Design and Access Statement

Land at Highfield House,

London Road, Little Chesterford, CB10 1UB

Proposed part demolition of the existing garage, construction of 2no. dwellings and associated infrastructure including access, parking, garages and ancillary works.

Figure 7: Pre-application advise proposal to the left, application to the right

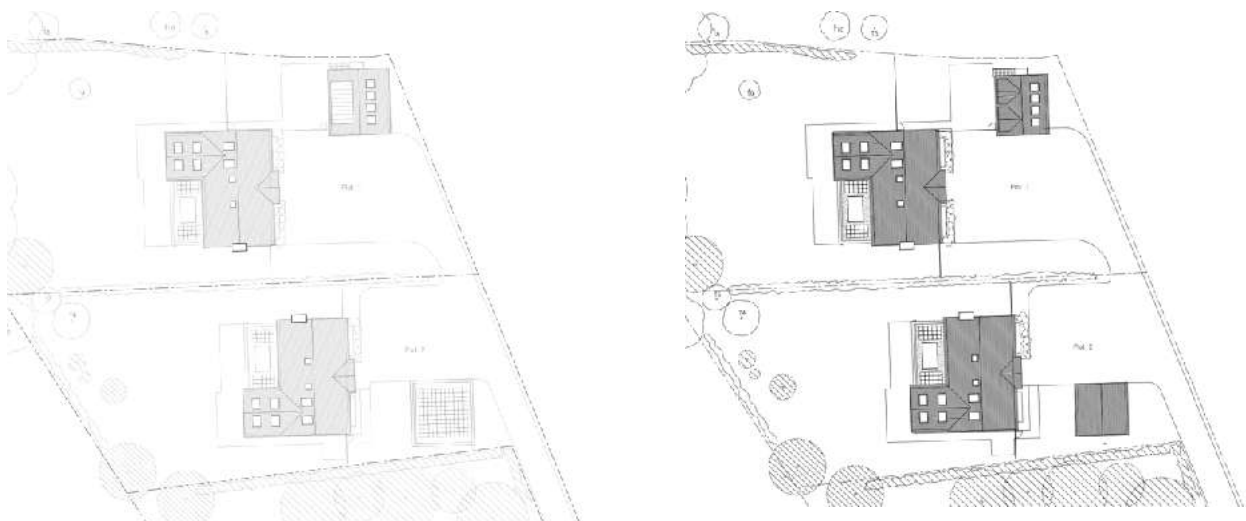
1. The last point of contention is the size of the proposed outbuildings – please scale both down by changing the garages into carports (by omitting the garage doors and making them open). That way you can make them 5.5m x 2.9m internally (instead of 7m x 3m) but no less than 5m x 2.5m which are the minimum dimensions for a car parking space.

2. You should also reduce the bulk and size of the plot 1 outbuilding by reducing its height. This is an important point as above.

Our response: The revised proposal submitted reduce the size of the proposed garage, although this was the size indicated as the previous approved scheme. Parking spaces are now 5m x 2.5m for Plot 2 with an open carport arrangement. For Plot 1 this same spaces has been allowed but an additional 1.1m at the front with side access for additional storage of bikes, lawn mover etc. The carport also benefit from an open arrangement at the front.

Our response: We were only able to reduce the height very slightly to still accommodate an office space above the garage due to the reduce footprint. The large dormer proposed during the pre-application stage has also been removed and replaced with pitch dormers that reduce the appearance of the massing of the carport.
